Transmittal
Submittal Review Response

Re: **Project No.:** 253117-261237
Project Name: PSTA Clearwater Multimodal Transit Center
Client: Pinellas Suncoast Transit Authority

Submittal No.: **S-051200-002-F**
Title or Description: **Structural Steel Framing Canopy & Pavilion**
Type of Submittal: **Shop Drawing** **If other**
Status
Review Code: Code 4: Approved As Noted; Resubmit
Other:
Review Comments:

1 MECHANICAL RENOVATION ROOF PLAN
1/4" = 1'-0"

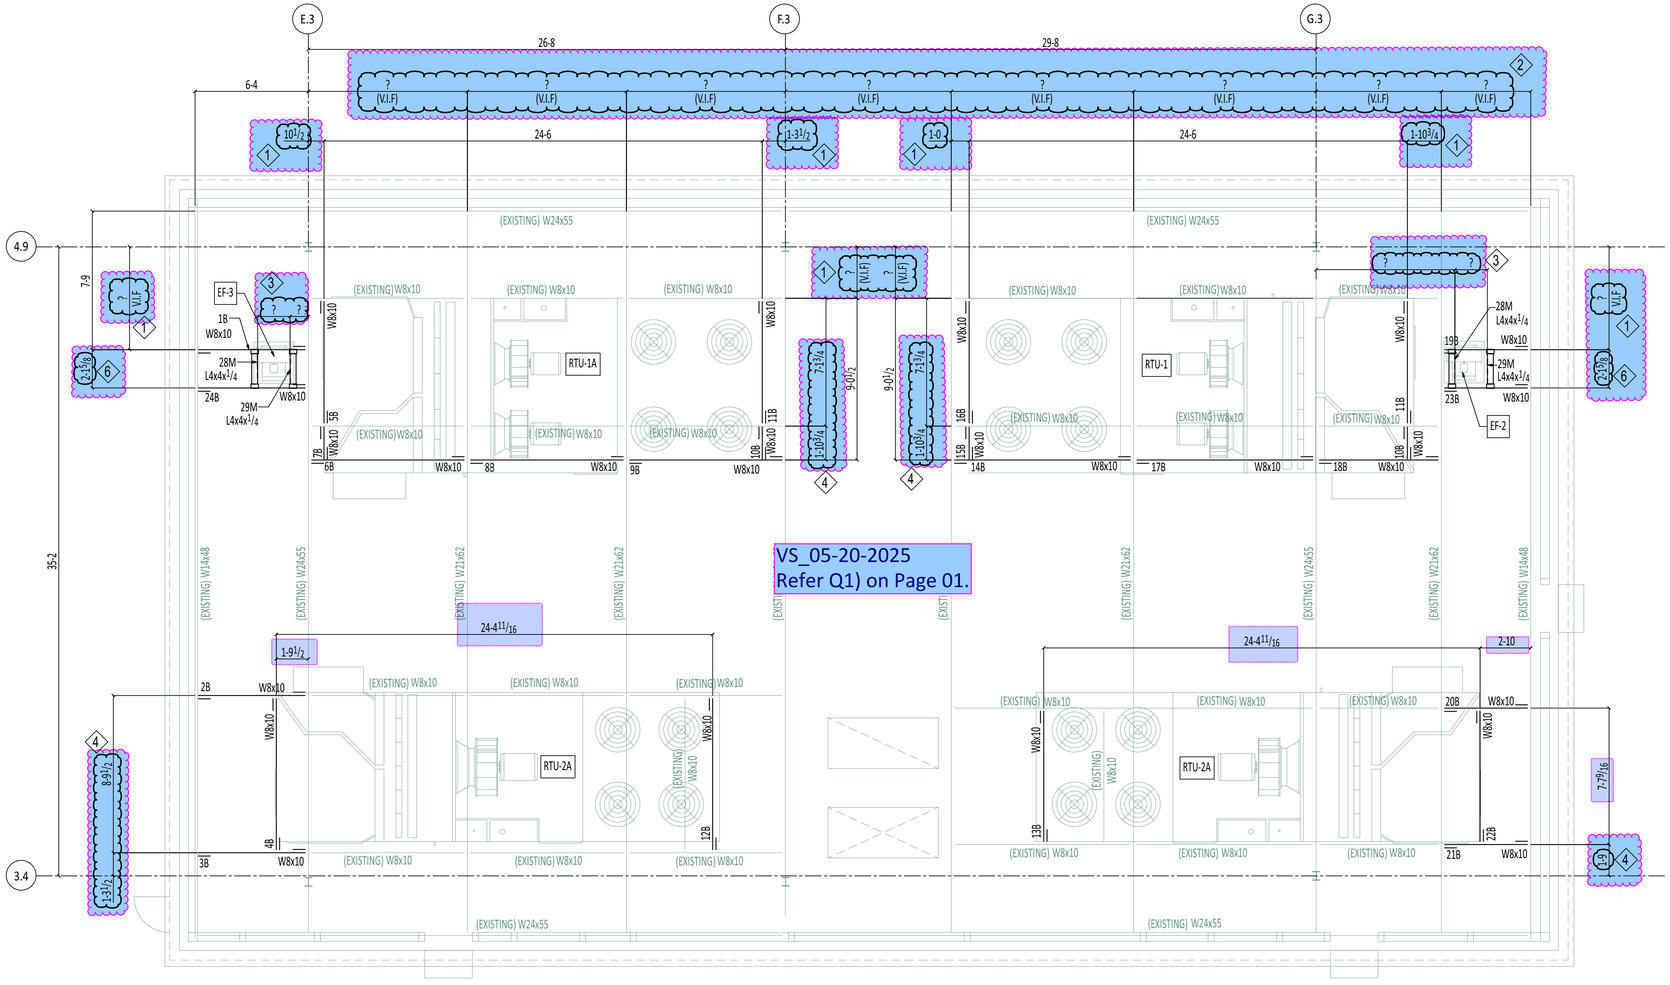
VS_05-20-2025
Q1) We could not find any updated information about new steel to steel locating and Exist steel to new steel locations(Refer Page 02).Please provide updated drawing to proceed further.
